UN Regulation No. 10 (Electromagnetic Compatibility)

Proposal for a new 07 series of amendments to UN Regulation No. 10 (Electromagnetic compatibility)

Submitted by the expert from by the Informal Working Group on Electromagnetic Compatibility*

Figure 1
Charging mode configuration for Annex 15"

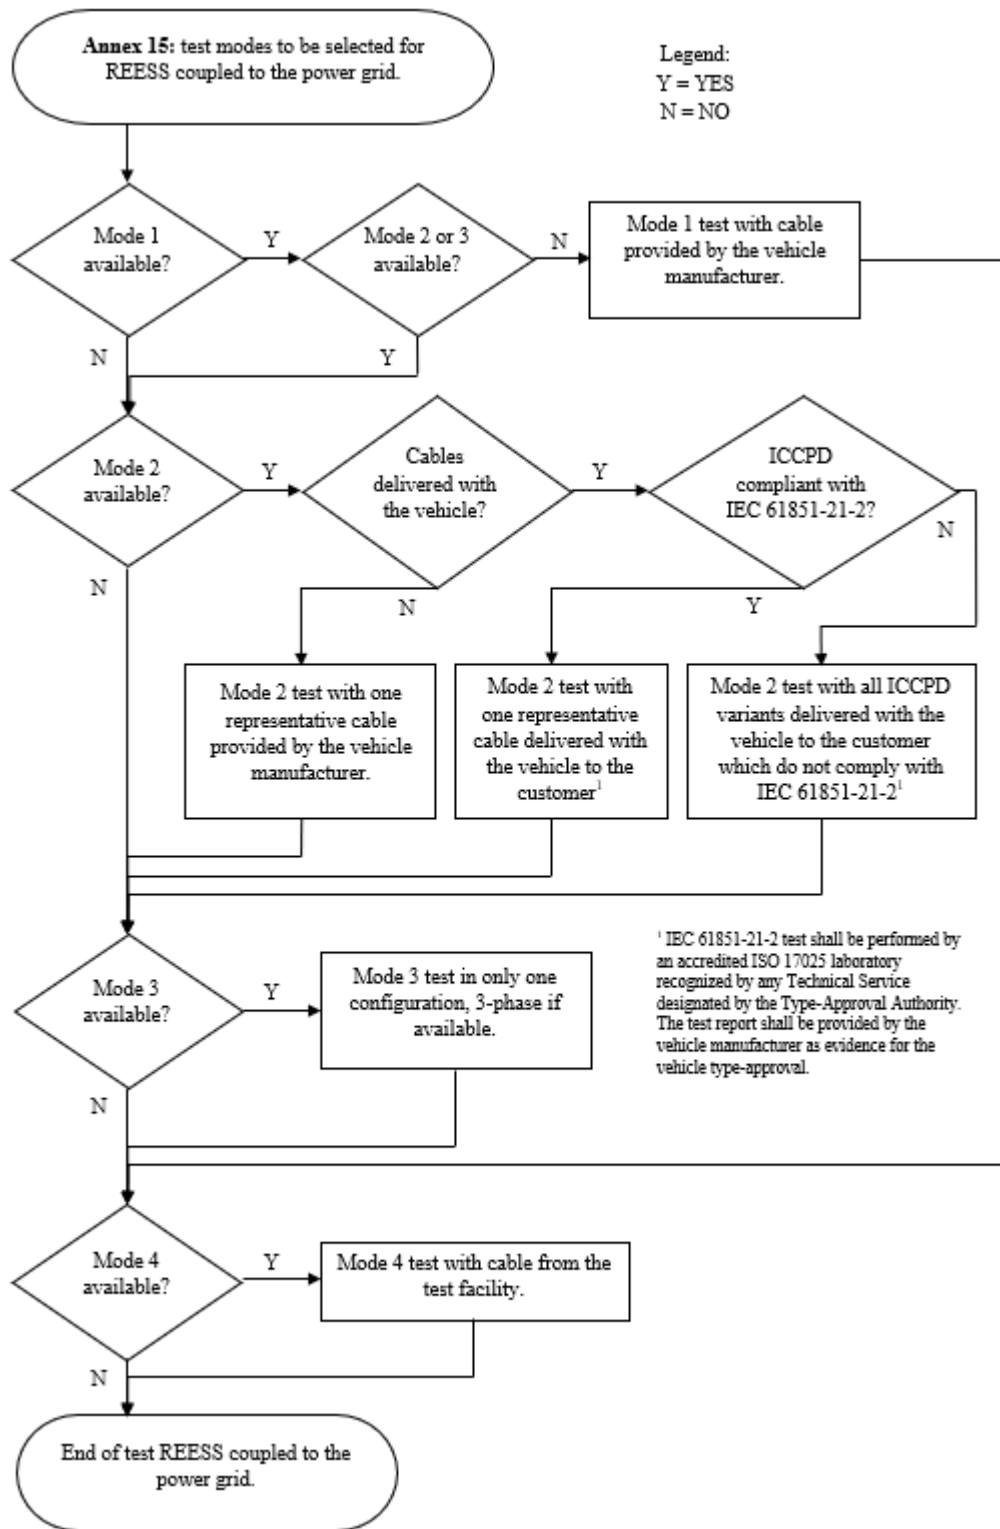
The vehicle shall be tested in the charging mode configuration (if available on vehicle) as defined in flowchart of figure 1

41. Annex 14 is to be suppressed, see para. 17 above.
42. In Annexes 15 and 16 the following modifications were made:
- (a) A flow chart is introduced for clarification of the charging mode configurations to be tested. For general explanation of the flow chart see Annex 4 with the following additional explanation:

"Figure 1d

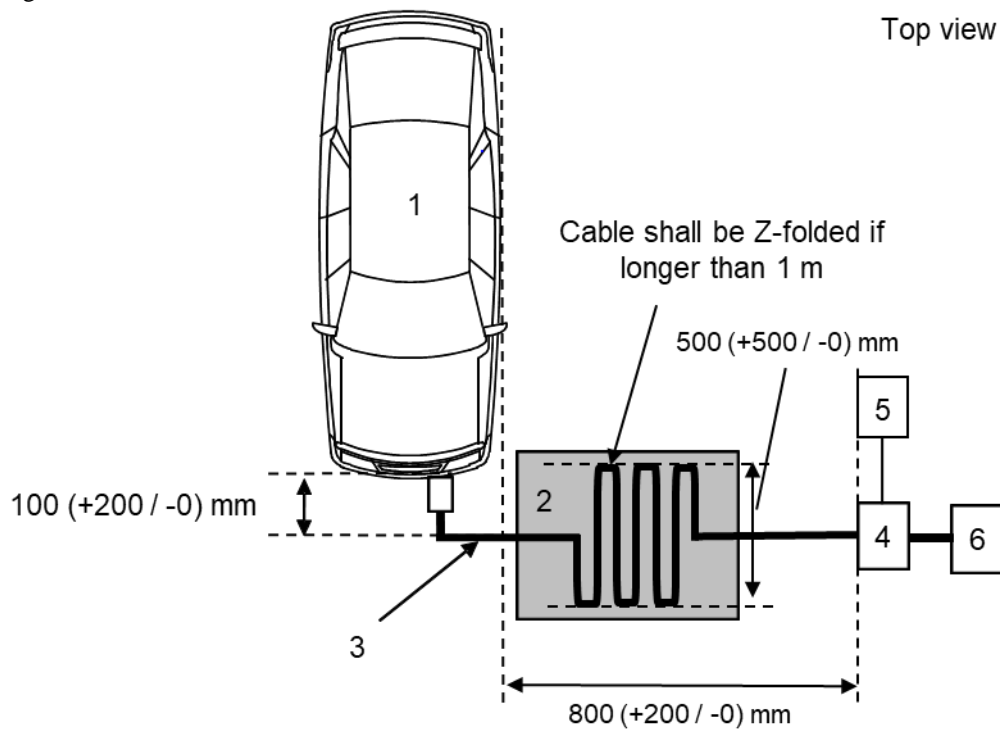
Figure 1d, amend to read:

Figure 1
Charging mode configuration for Annex 16"

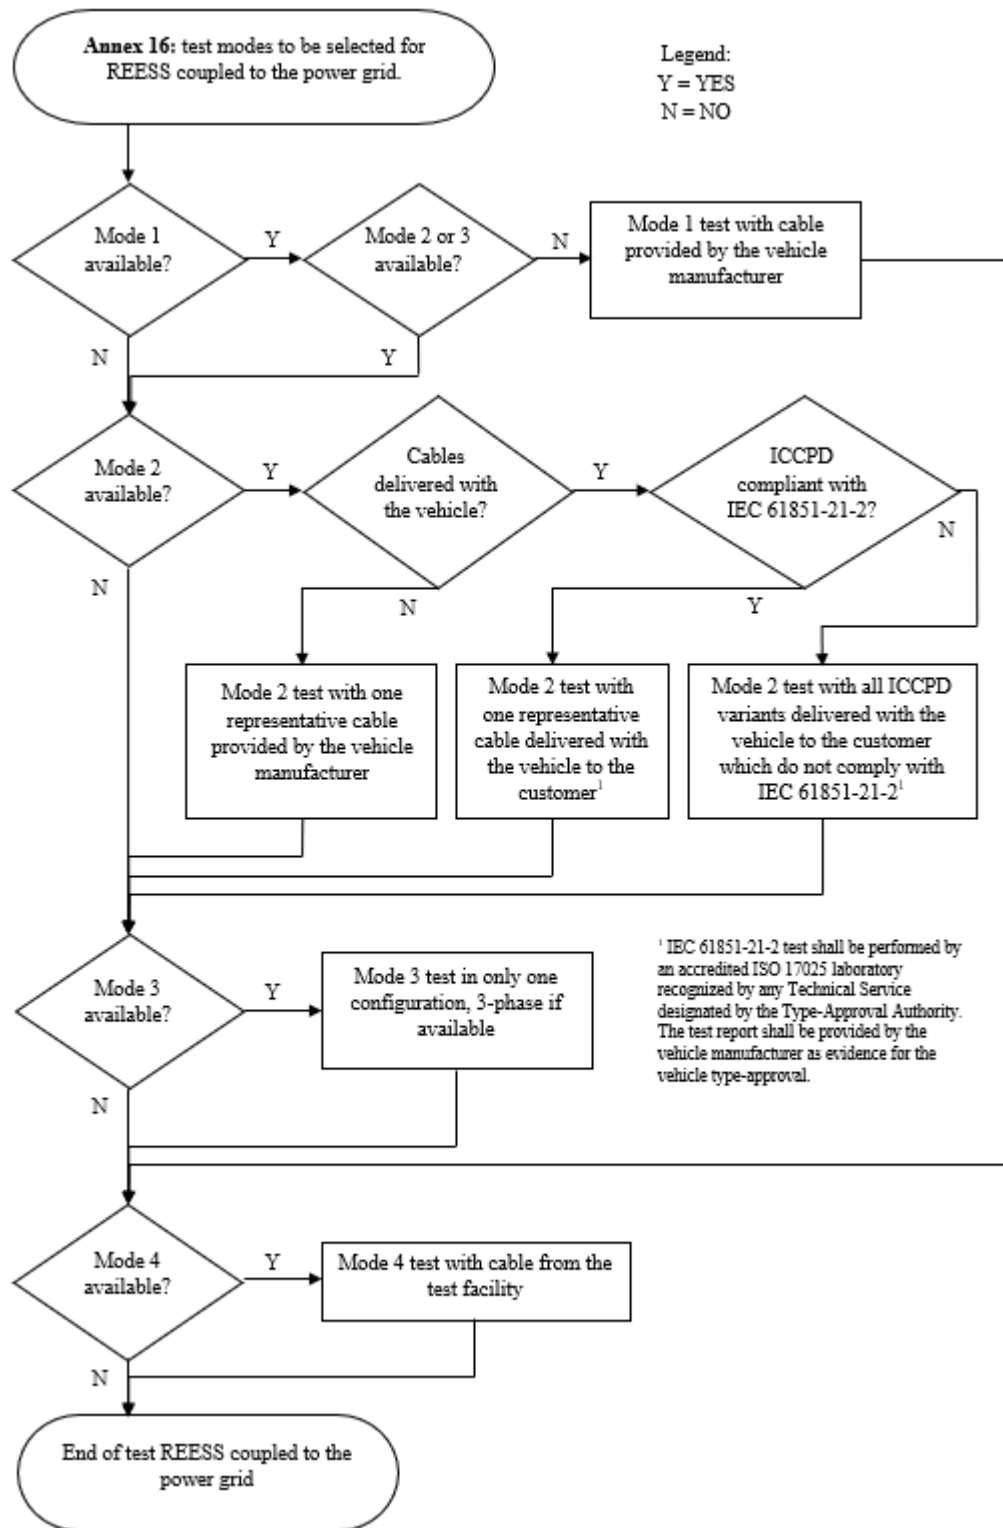
The vehicle shall be tested in the charging mode configuration (if available on vehicle) as defined in flowchart of figure 1

"Figure 1b

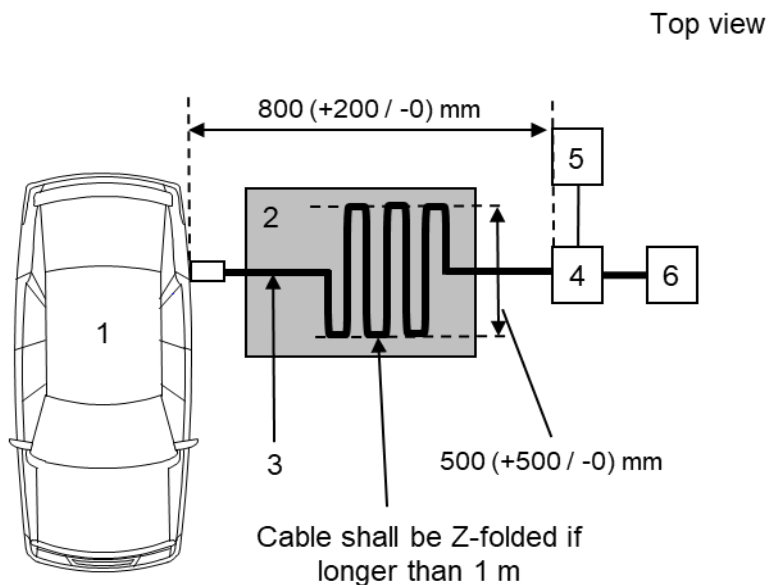
Figure 1b, amend to read:

"Figure 1d

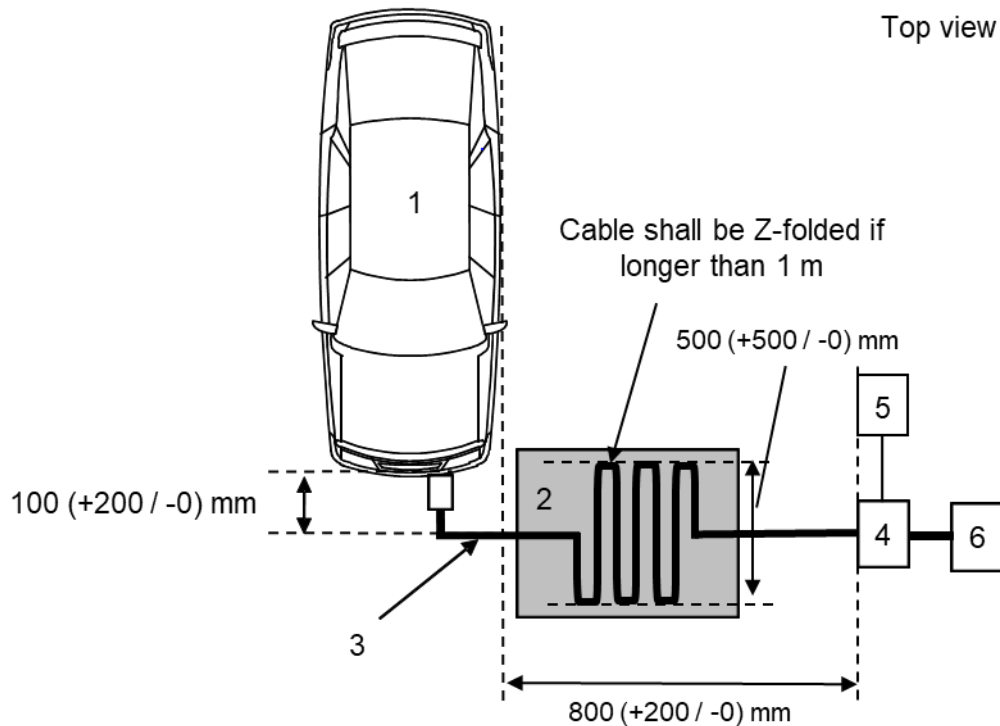
Figure 1d, amend to read:
